SINGAPOREAN NOTICES TO MARINERS

II
NOTICES TO MARINERS AND CHART CORRECTIONS

Block for Chart No GSP1

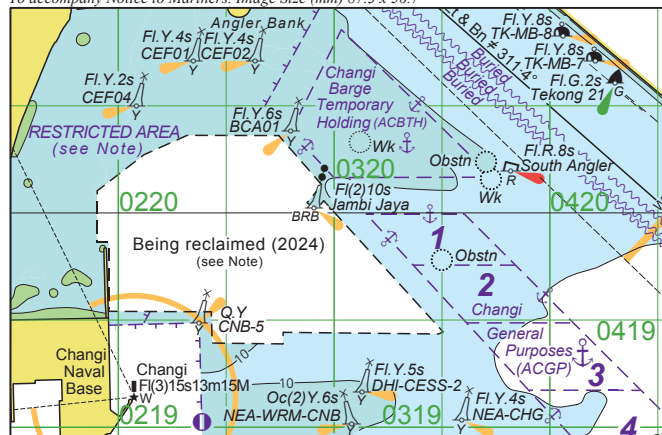
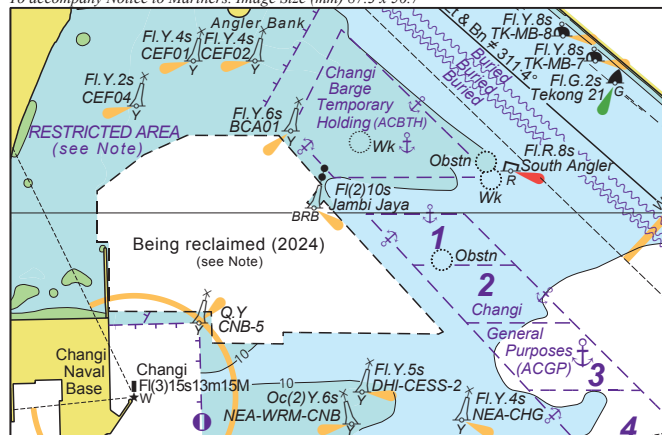
GSP1/SP1	8 Ed 17/01/24 Last NM 58/2024 (Maritime and Port Authority of Singapore)	*NM 66/2024
Insert	the accompanying block, centred on:	1°19·96'N 104°03·03'E

Block for Chart No 502

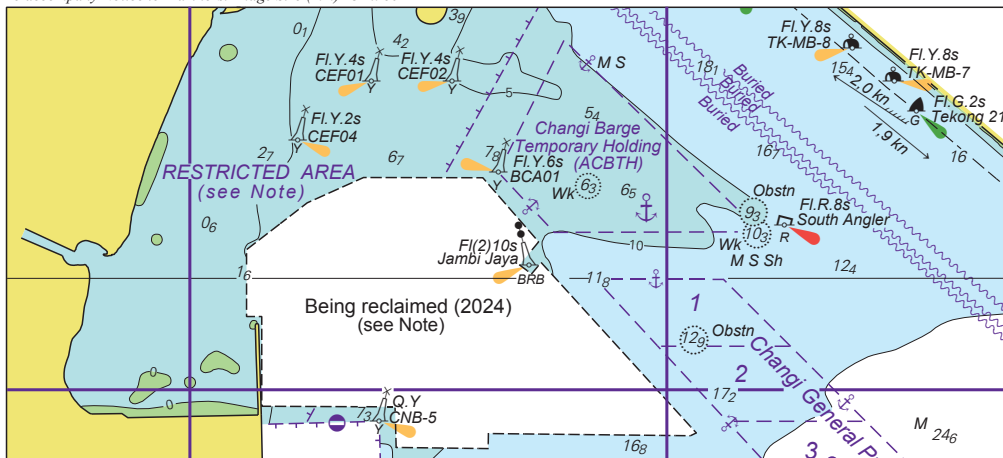
502	9 Ed 15/10/21 Last NM 53/2024 (Maritime and Port Authority of Singapore)	*NM 66/2024
Insert	the accompanying block, centred on:	1°20·16'N 104°02·84'E
